CU Certification of Completion

CU BACKFILL/ENGINEERED CAP COMPLETION APPROVAL - FORM 2						
Reporting Date	11/19/2009				Placement Start Date	10/15/2009
CU Number	3				Placement End Date	11/10/2009
Approximate CU Centroid	Northing	1614048	Easting	736253	NY State NAD 83	
CU Size	4.87	Acres				
Backfill Area	3.55	Acres*				
Cap Area	1.32	Acres				
Backfill Surface Mean Tri+ PCBs Concentration (when required)		NA		mg/kg		
Number of nodes sampled		NA		mg/kg		
Backfill X	Type of Backfill Type 1, Type 2, Nearshore, 15%	Reference to appropriate drawings attached to Approval Form 1 CU3 Backfill and Cap Plan, 10/13/09				
Cap X	Type of Cap Type "A" Low Velocity Cap and Type "A" Medium to High Velocity Cap	Reference to appropriate drawings attached to Approval Form 1 CU3 Backfill and Cap Plan, 10/13/09				
CU Checklist		Indicate one of the following			Reviewer Initial Acceptance

Narrative Summary of Backfill and Capping and EPA Backfill and Capping Agreements

CU03 - POST BACKFILL PLACEMENT
HUDSON RIVER, NEW YORK
HUDSON RIVER SEDIMENT REMEDIATION PHASE 1 PROJECT

DRAWING TITLE: CU-5 TYPE 2 BACKFILL PLACEMENT ACCEPTANCE SURVEY

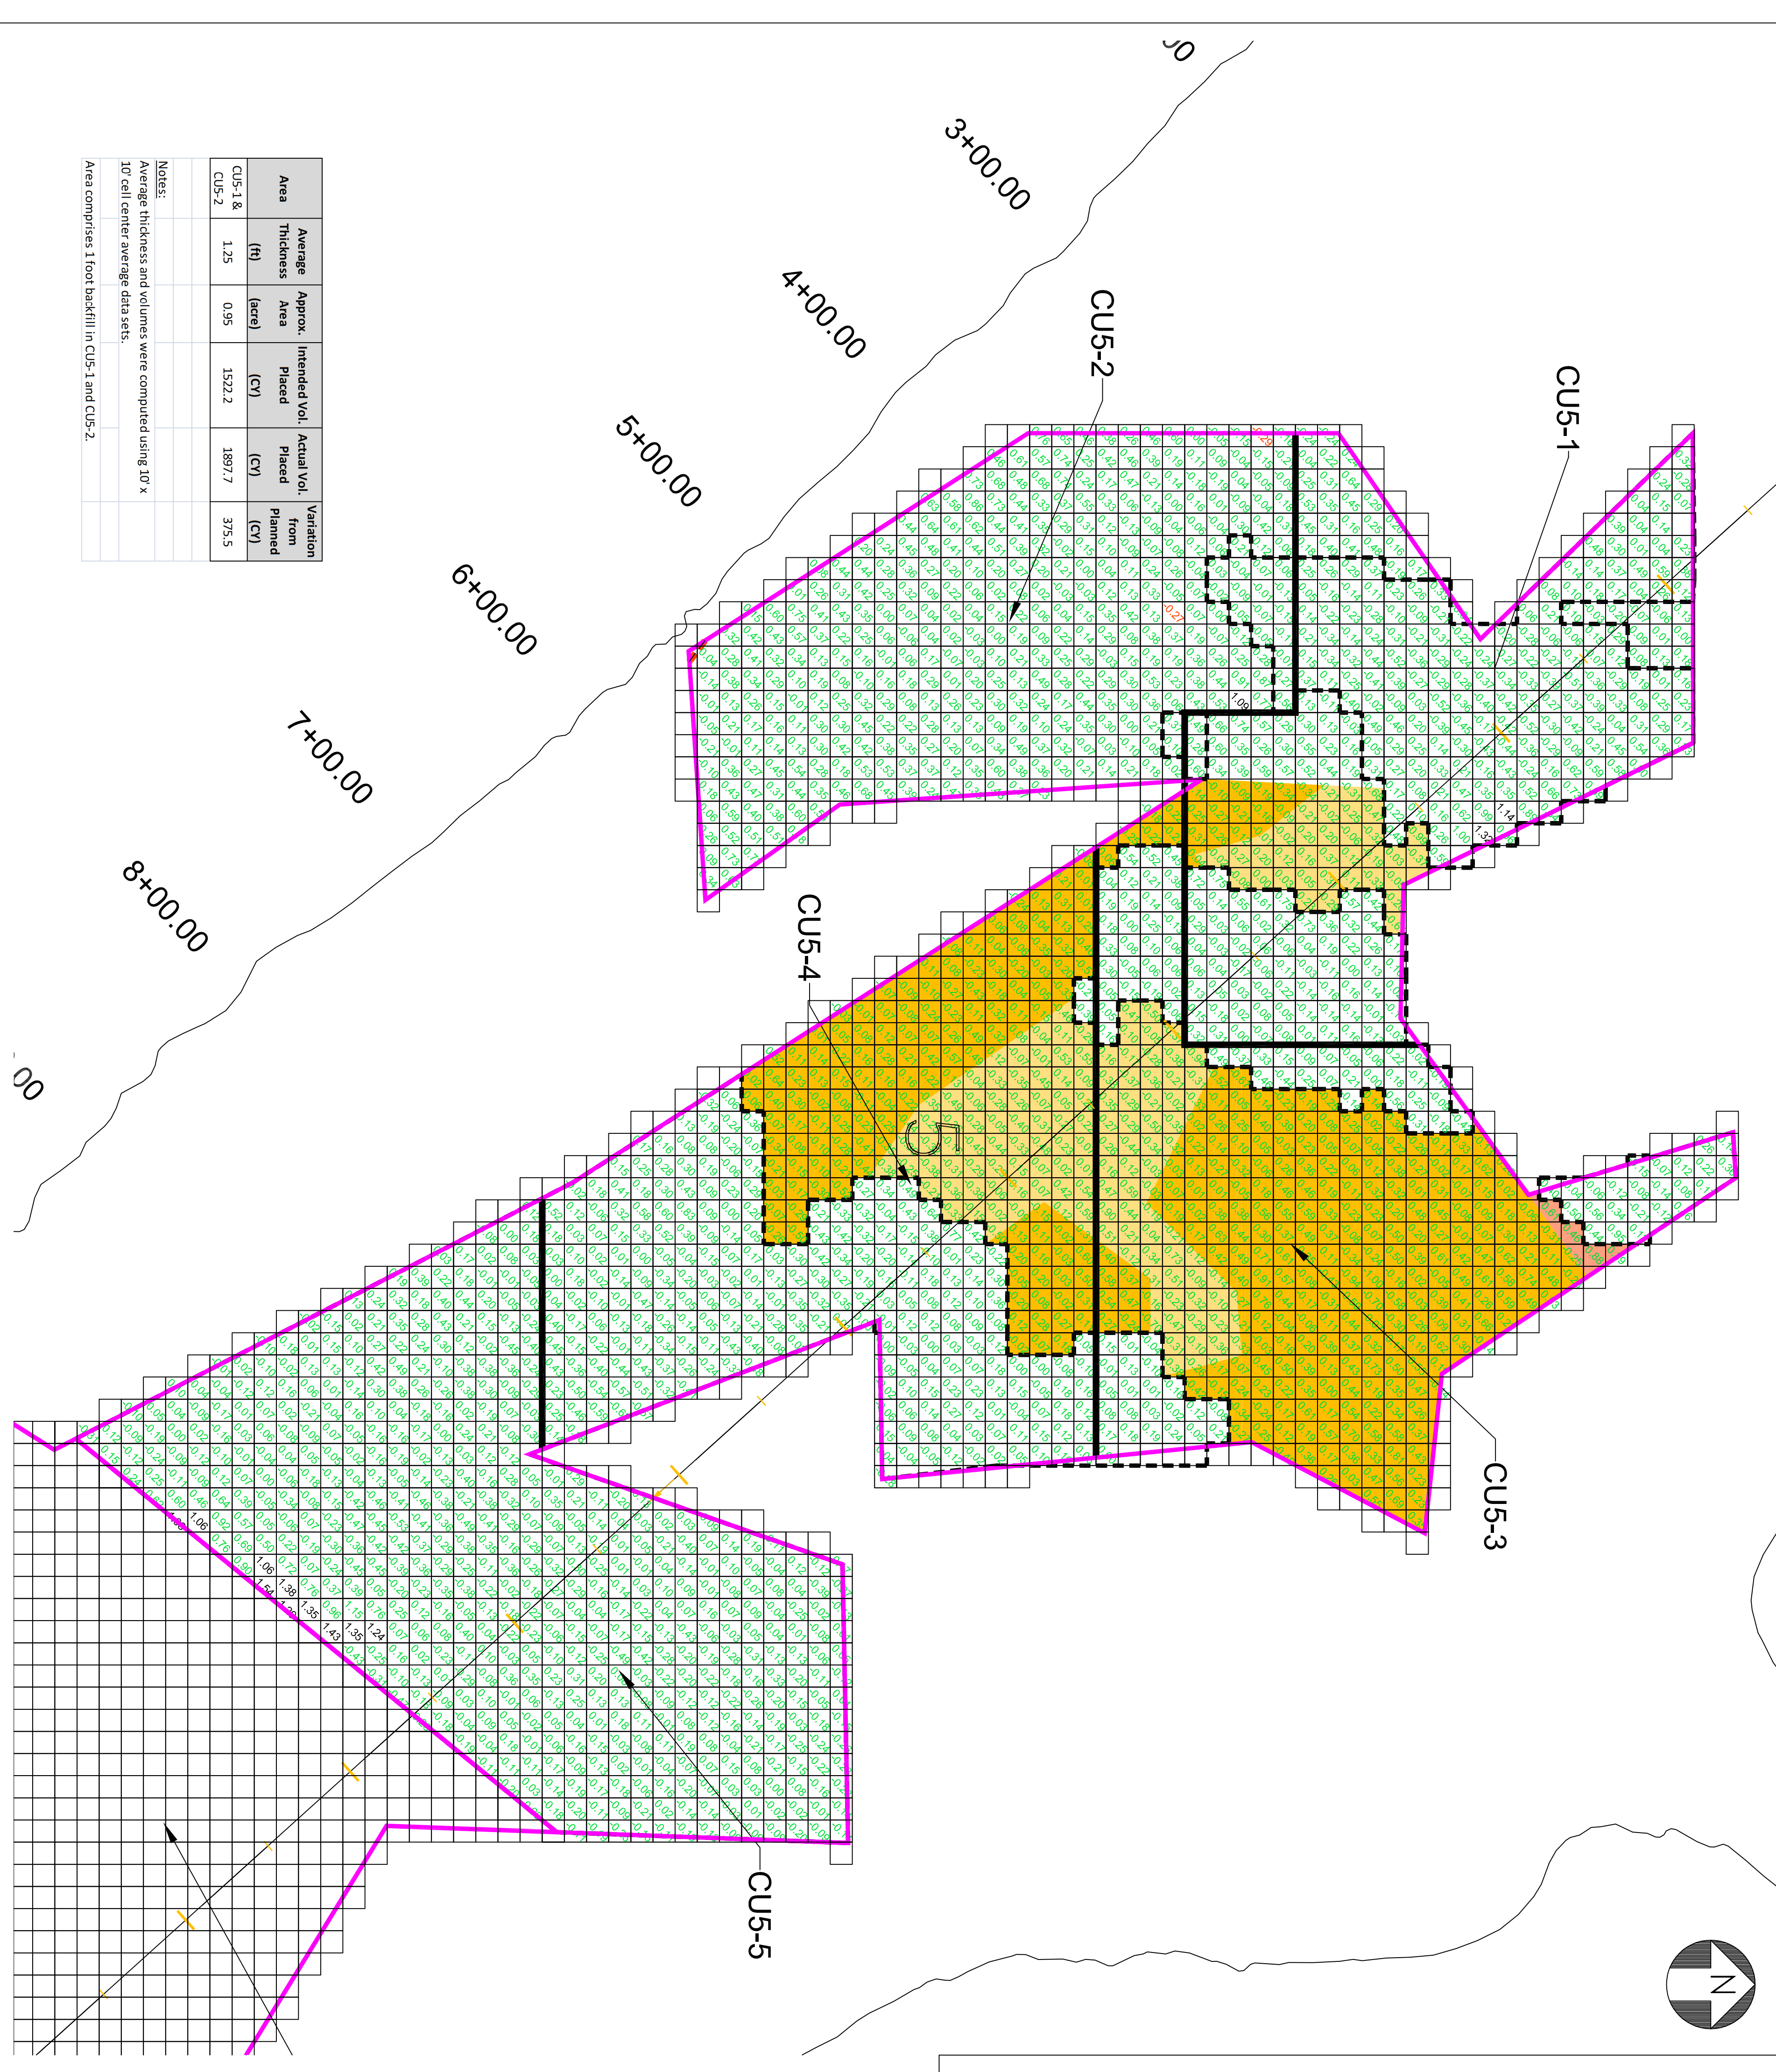
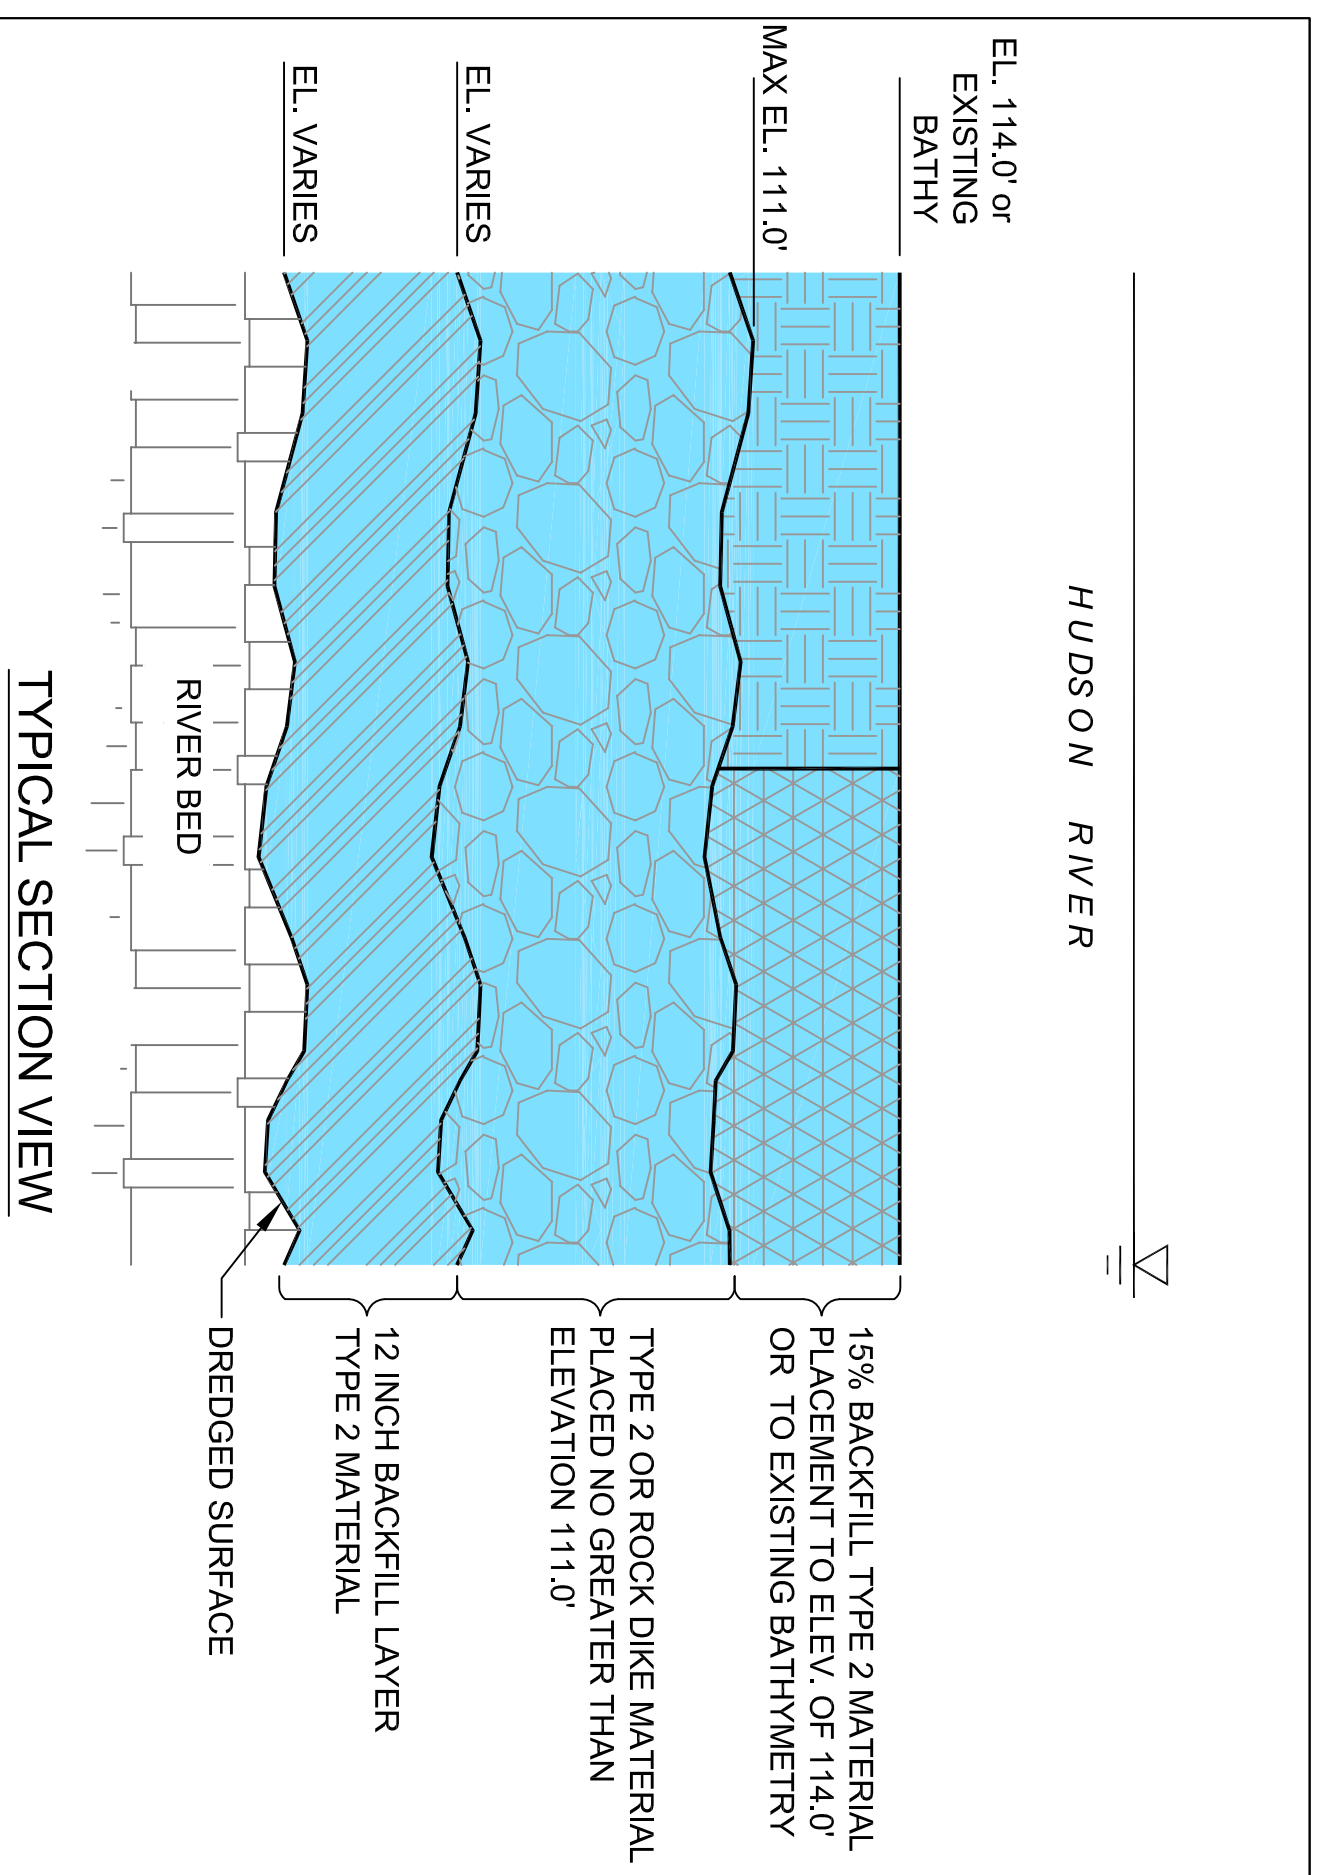
5. During the 4:00 PM meeting on October 17, 2009, EPA requested Actual 15% volumes placed be included on the Backfill Acceptance Drawings, to which GE agreed (see Note 3 on the Backfill Acceptance Survey Drawing, dated October 19, 2009). EPA also requested the 15% backfill borders be depicted on the Backfill Acceptance Drawing, to which GE agreed.

1. BUCKET REFUSAL AREAS NOT INCLUDED IN CU APPEPTANCE PROCESS.
2. 15% BACKFILL AREA BORDERS SHOWN FOR REFERENCE. 15% PLANNED AND ACTUAL VOLUMES INCLUDES ENGINEERED SIDE SLOPES, WHICH ARE NOT DEPICTED ON DRAWING.
3. 4,704 CY OF 15% BACKFILL MATERIAL PLACED DURING BACKFILLING. BACKUP CALCULATIONS AVAILABLE UPON REQUEST.

CU 5
CAP A TYPE
ACCEPTANCE SURVEY

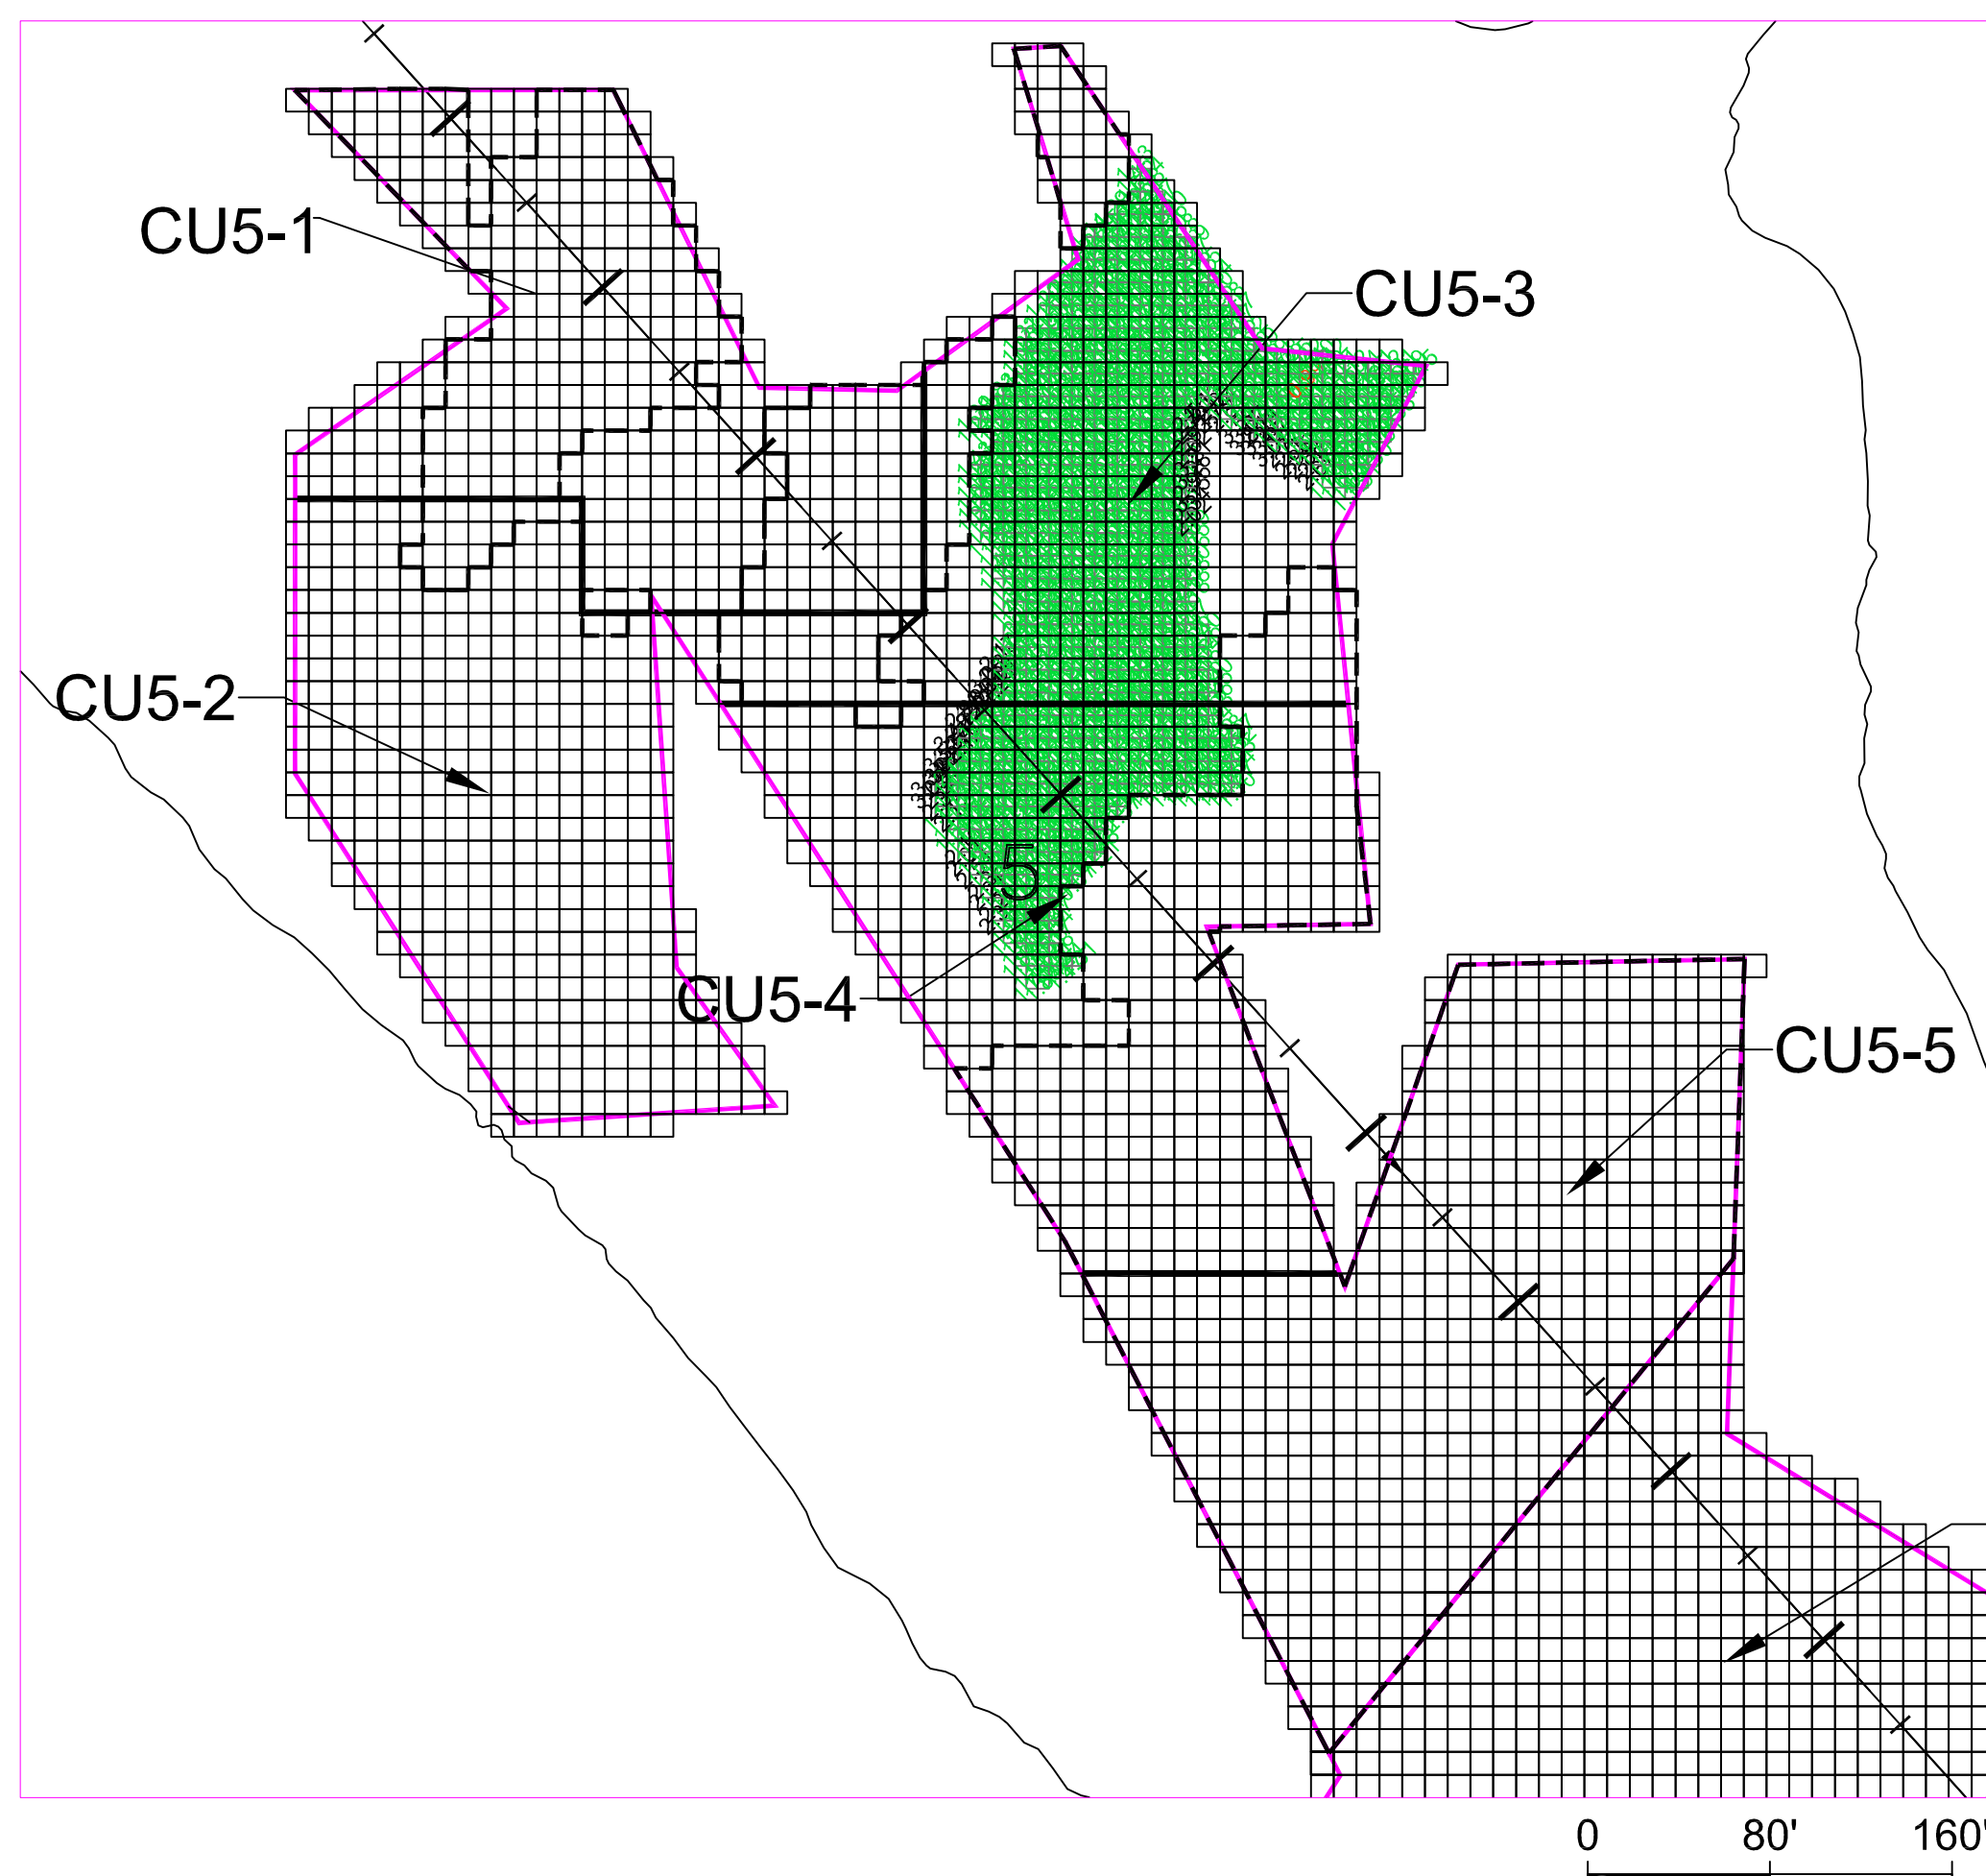
2. During the 4:00 PM meeting on October 5, 2009, GE presented acceptance surveys of the top of cap elevations in CU5. Based on the information presented by GE, EPA accepted that the top of cap elevations were within the required design tolerances. The Cap Acceptance Survey Drawing, dated October 19, 2009 is included in this package.
